# CITY OF SACRAMENTO

- SUBJECT:
1. Subdivision Modification to waive service connections
  2. Tentative Map (P-9016)
  3. Appeal of the conditions of the Special Permit which requires a reduction of parking ratio from 2.0 to 1.5 parking spaces per unit; shake or heavy composition shingles; and redesign of the site plan to allow for more north/south oriented units.

LOCATION: Southeast corner of San Juan Road and Miramonte Drive

ADOPTING FINDINGS OF FACT, APPROVING A REQUEST  
FOR SUBDIVISION MODIFICATION AND TENTATIVE MAP  
FOR DEL VERDE SQUARE (APN: 225-230-40) (P-9016)

EXHIBIT "D"

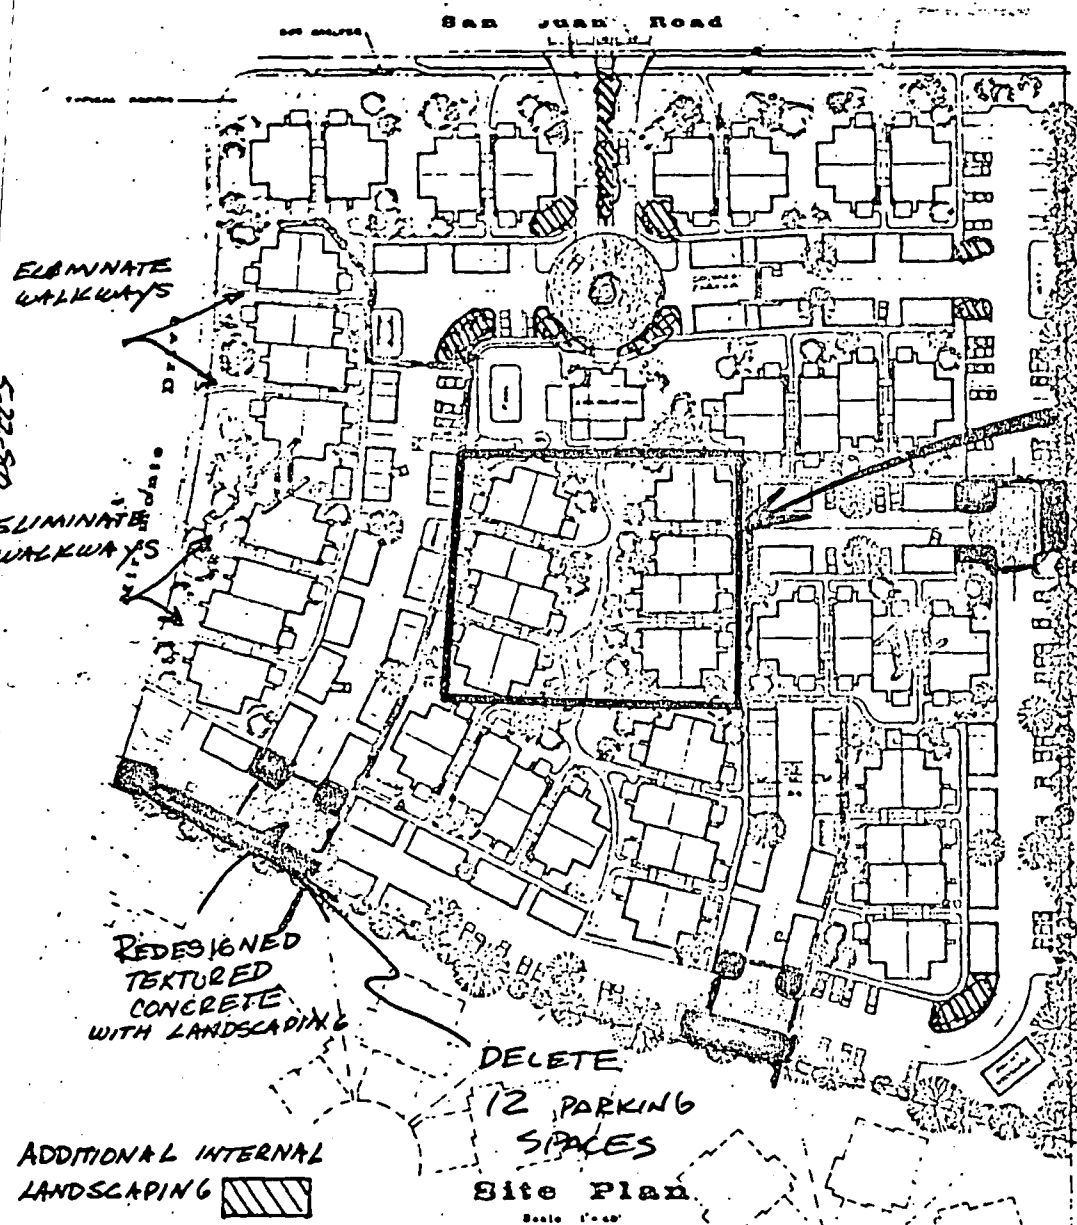
2. Condition "e" (pg. 3 of CPC report): "The 32 units as shown on Exhibit "D" shall be redesigned to orient north/south in order to accommodate a greater percent of north/south units."
3. Condition "h" (pg. 6 of CPC report): "The parking ratio shall be reduced to 1.5 and the eliminated parking shall be replaced with landscaping." This condition was added by the Planning Commission.

2. Condition "e": This condition was suggested because it would allow for more north/south oriented units. The project as proposed by the applicant consists of 80 units (45%) oriented in a north/south direction. The recommended condition would require 32 additional units be oriented north/south which would increase the percentage of N/S units to 64 percent (112 units). This condition is consistent with the South Natomas Community Plan which requires a minimum of 60 percent north/south units.

3. Condition "h": This condition suggests a reduction in parking spaces. Staff recommended that 12 parking spaces be deleted along the southern property line as shown on Exhibit "D". This was suggested because there is a dwelling unit that will be only 5-10 feet from these parking spaces, which could cause a noise problem for the adjacent resident. This suggestion would reduce the parking ratio to 1.9 spaces per unit.

CHANGE THE LOCATION OF 32 UNITS TO REFLECT A NORTH-SOUTH ORIENTATION

EXHIBIT "E"

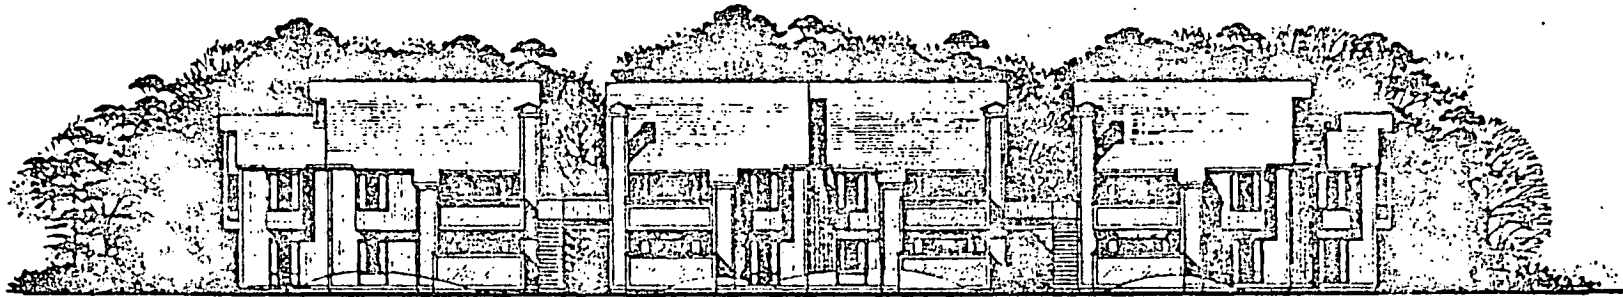
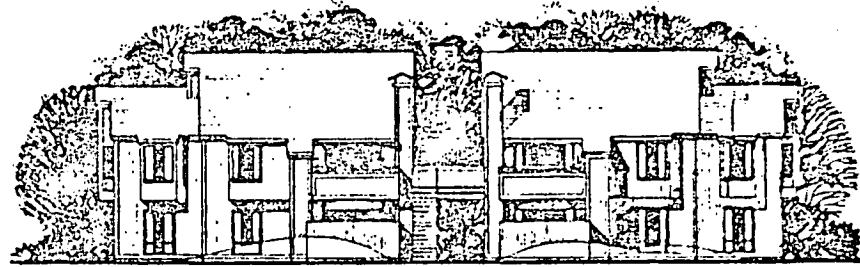
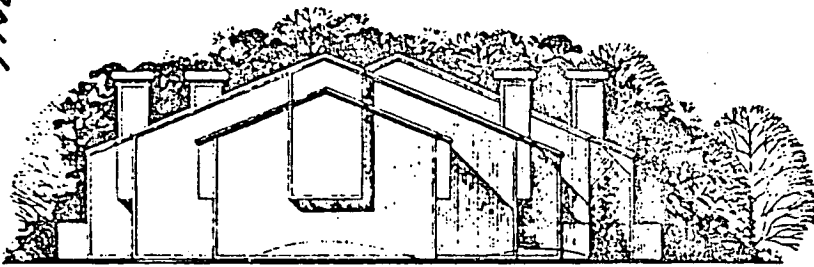
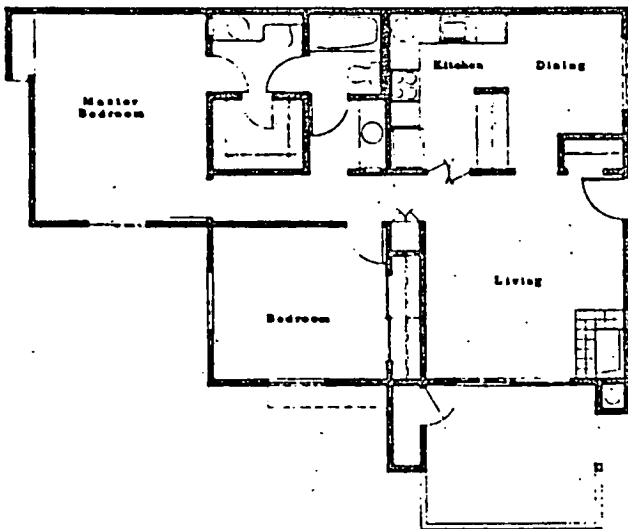
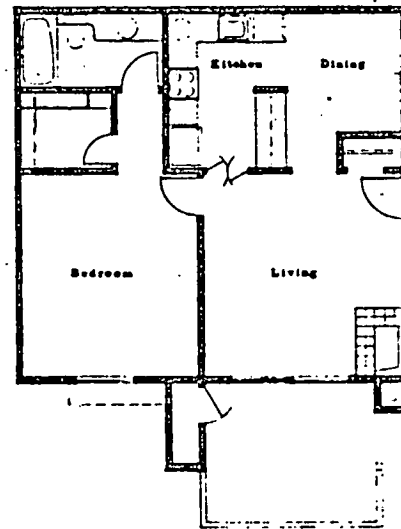
1. In order to visually break up the end walls of the cluster units (Exhibit E), windows should be provided. This additional element will improve the design of the units as viewed from the street and within the project.
2. The elevations do not indicate the roofing materials that will be utilized. Staff suggests that a shake or a heavy imitation shake type material be used.

1. Condition "d": The Planning Commission and staff have suggested the use of a heavier roof material because it would allow more texture and improve the overall appearance of the condominium units. This requirement is common for most condominium projects in the City.
